ADDENDUM NO. 3 TO 18-0126-4

FOR: FLEET SERVICES FACILITY

ADDENDUM No. 3

DATE: Thursday, January 17, 2019
PROJECT: Fleet Services Facility (Bid No. 18-0126-4)
Chatham County Georgia
BY: COGDELL & MENDRALA ARCHITECTS, PC (Architect)
517 East Congress Street
Savannah, GA 31401

1 AIR COMPRESSOR WITH DRYER DETAIL
P0.02 NOT TO SCALE

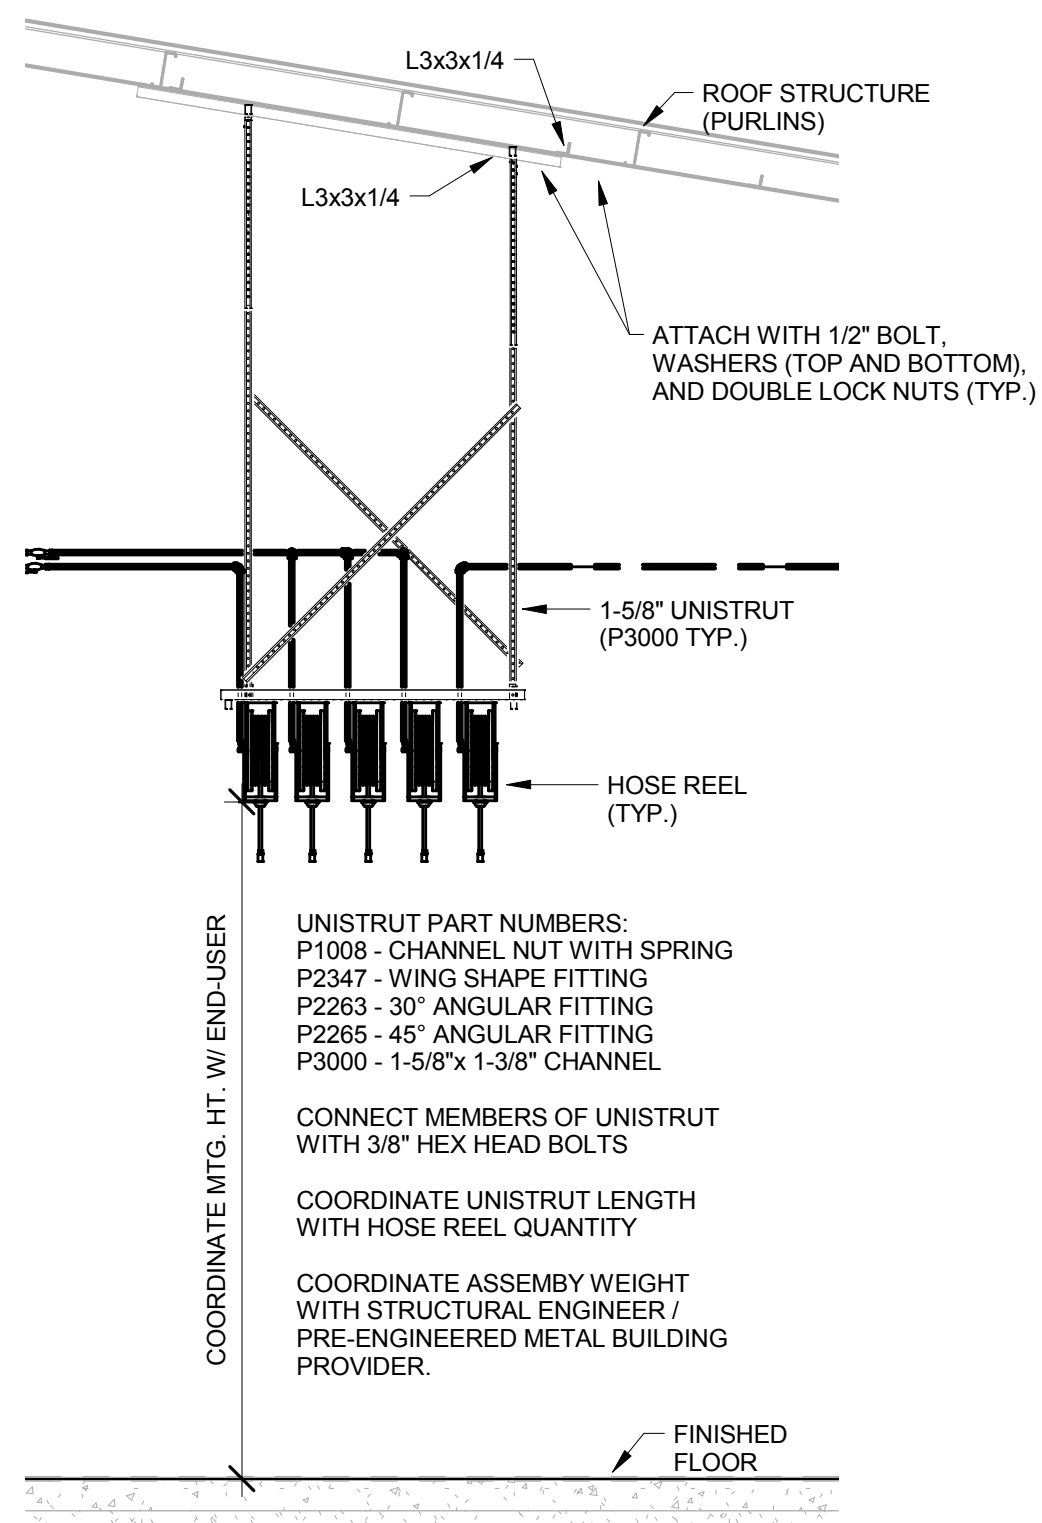
A. Provide air compressor specifications.

1.A/E Response: See Specification Section 22 15 10 Compressed Air System.
